# RESPONSES TO QUESTIONS ON DWDM

### CLARIFICATION 1

Figure 1: Envisioned Coverage

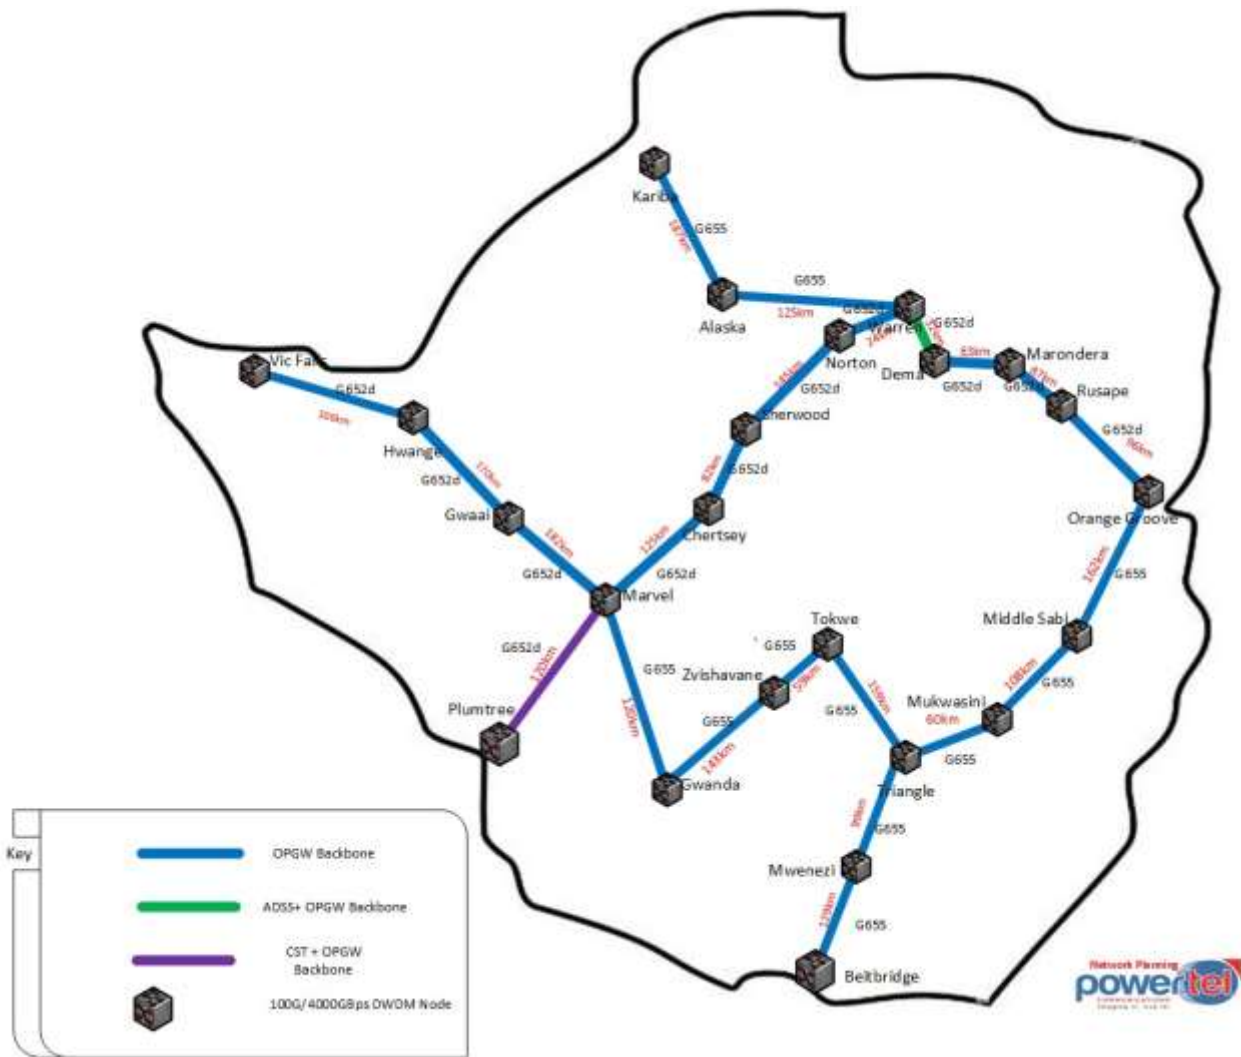
RFP Section and Page #	Rfx Requirement	Bidder Questions	Powertel Responses
Figure-1	DWDM network Diagram	What is the attenuation to be considered. Should we consider 0.22dB/Km as this is OPGW and a 3dB EoL margin?	Refer to Technical Addendum, We have specified the fibre cable type (i.e. ADSS, OPGW, etc.) and standard (i.e. G655, G652.d) on the technical addendum
Figure-1	DWDM Network Diagram	For a network that should be 40 Channels or more with higher bandwidth it is important to note that distances should be around 100kms spans (25dB). However it seems some of the spans are more than 100kms to a level of even 182 kms. Is PowerTel considering intermediate amplifiers over here for a network that in future can handle rates of 400G, 800G lamdas as well?	Suppliers to provide a solution that can support the provided distances. The nodes are based on existing substation premises.

<b>Bidder Queries on Powertel_ WDM network</b>						
<b>System</b>	<b>Reference Document</b>		<b>Pwt Requirement</b>	<b>Bidder Response</b>		<b>Pwt Response</b>
		<b>Page</b>		<b>Clarification sought?</b>	<b>Bidder proposal</b>	
<b>DWDM Network</b>	ICT-PWT-03-2024-1	20	Figure 1 : Envisioned	Please provide a clear image, the site name and distance of the current image is unclear		Provided in Addendum
	ICT-PWT-03-2024-1	21	Additional map	Please provide a clear image, the site name and distance of the current image is unclear		Provided in Addendum
	ICT-PWT-03-2024-1	20-21		What is the fiber attenuation coefficient? Is it can be set to 0.275db/km, and also consider 3dB margin per fiber span?		We have provided fibre types for all the spans
	ICT-PWT-03-2024-1	20-21		some fiber distance is more than 100km, in order to improve optimal transmission performance, is it possible to add intermediate sites to		Suppliers to provide a solution that can support the provided distances. The nodes are

DWDM ADDENDUM	7, 9	Figure 1: Envisioned Coverage Figure 2 : Integration with Existing Equipment	in chapter 3.4, the fiber type is G.652 and G.655, but in Figure 1 and Figure 2, the fibre type is not indicated , should we assume that we choose the fibre type at random to meet the requirement of both G.652 and G.655 without any equipment components change?		Refer to figure 1 on the addendum
	DWDM ADDENDUM	7, 9	Figure 1: Envisioned Coverage Figure 2 : Integration with Existing Equipment	in document "DWDM ADDENDUM", the fiber attenuation is not indicated , can we use 0.24db/km+3db margin for each fiber span? As this is highly recommended for best performance		Please utilise the recommended attenuation for the ITU-T G.652.D and ITU-T G.655
	DWDM ADDENDUM	7, 9	Figure 1: Envisioned Coverage Figure 2 : Integration with Existing Equipment	we cannot find the the fibre distance between: 1. Rusape to Orange Groove 2. Zvishvane to Shurugwi 3. Orange Groove to Mutare		Rusape Orange groove is 96km as indicated in figure 2 of the addendum  There is no mention of Shurugwi on the addendum  Orange groove to Mutare is 25km as indicated in figure of the addendum

Figure 2 : Integration with Existing Equipment

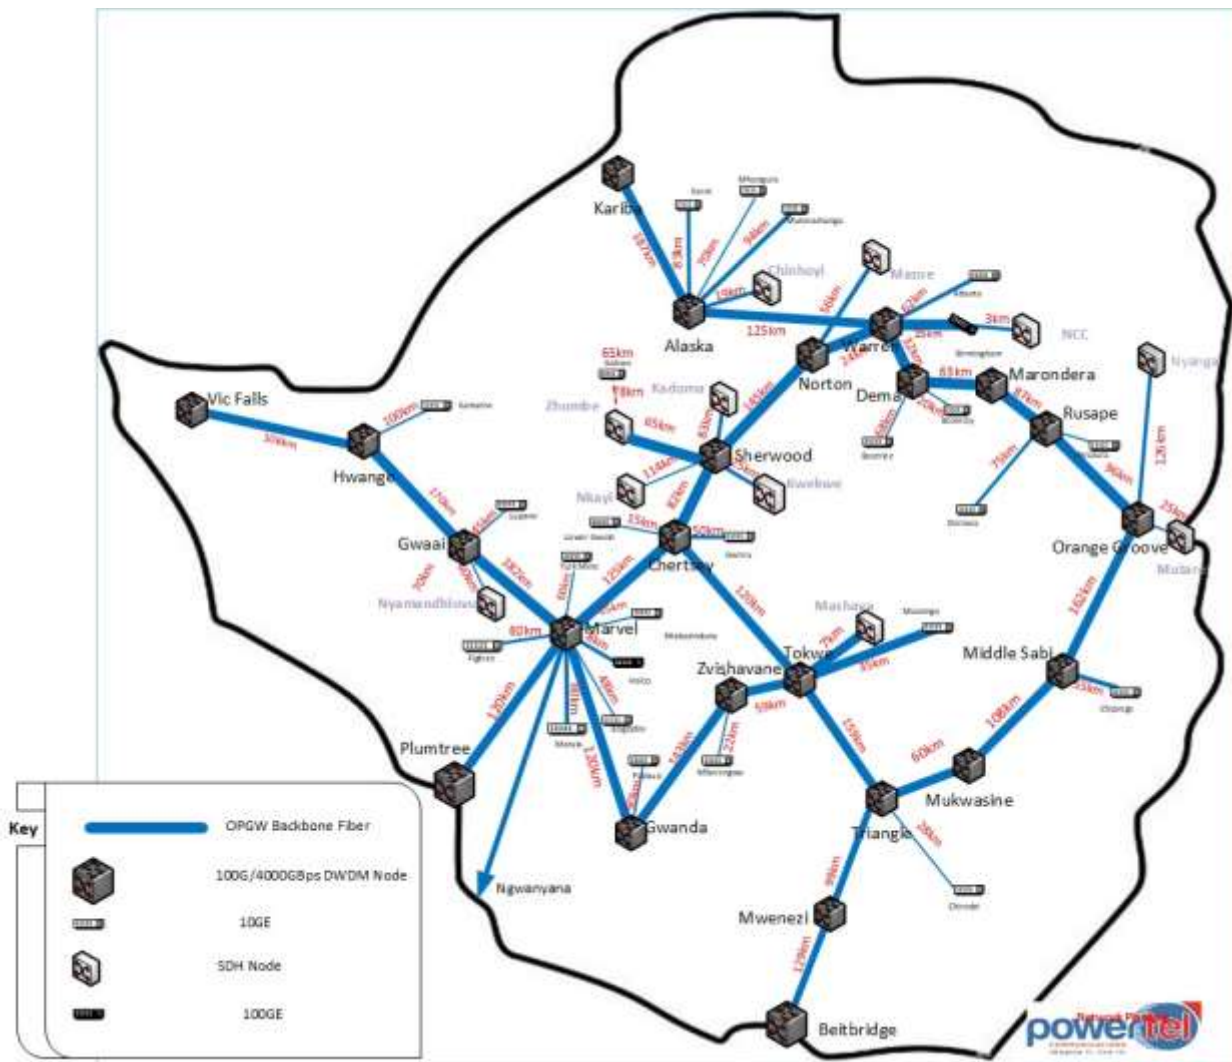
RFP Section and Page #	RFx Requirement	Bidder Questions	Powertel Responses
DWDM Figures	There are two figures of DWDM network	Which of the figure is to be followed for the design of the DWDM. Is it the figure -1 or the Figure-2 that is consisting of the new Network?	Please refer the technical specification addendum document in full. All parts should be used to propose the solution. Take note of the service matrix as well it will guide you on the design. The
Additions In the service	Extra interfaces required in the service matrix	Are these interfaces to be provisioned now or is it for future support?	At-least 1 x100GE add/drop interfaces, in addition to the services mentioned in the service matrix for Marvel, Warren and Gweru,  At-least 4 x 10GE and 4 x 1GE add/drop interfaces, in addition to the services mentioned in the service matrix in all nodes.
Capacity requirements	It should be able to transmit traffic between SDH node and DWDM node (Bidirectional)	A DWDM node is essentially transmitting wavelengths. Does this mean the Service node should have VC-x Cross Connect ability?	The DWDM equipment should support connections to SDH equipment as indicated in the service matrix. The DWDM equipment should support transportation of SDH traffic via the DWDM.

RFP Section and Page #	RFx Requirement	Bidder Questions	Powertel Responses
Figure-2	4000Gbps Node and 280Gbps node	Are we talking about the switching capacity over here?	The supplied Multiplexers should support up to 40 lambdas of 100Gbps capacity each
Bidding Procedure	Eligibility requirements	As a global company and not a local Zimbabwe company, we do not have a formal NSSA letter or equivalent, we however can provide a statement on behalf of the company's head of legal that the company has adhered and paid all required employer contributions and labor related payments by the applicable laws. Please confirm if that this is sufficient.	Yes that is what is being referred to as Equivalent document in country of origin.
Closing Date	Submission deadline	We kindly request an extension of the submission date. This additional time will enable us to provide a more comprehensive proposal and meet all requirements effectively.	The closing date/ bid submission deadline has been extended from 10 May 2024 to 10 June 2024 at 1000Hrs Local Time
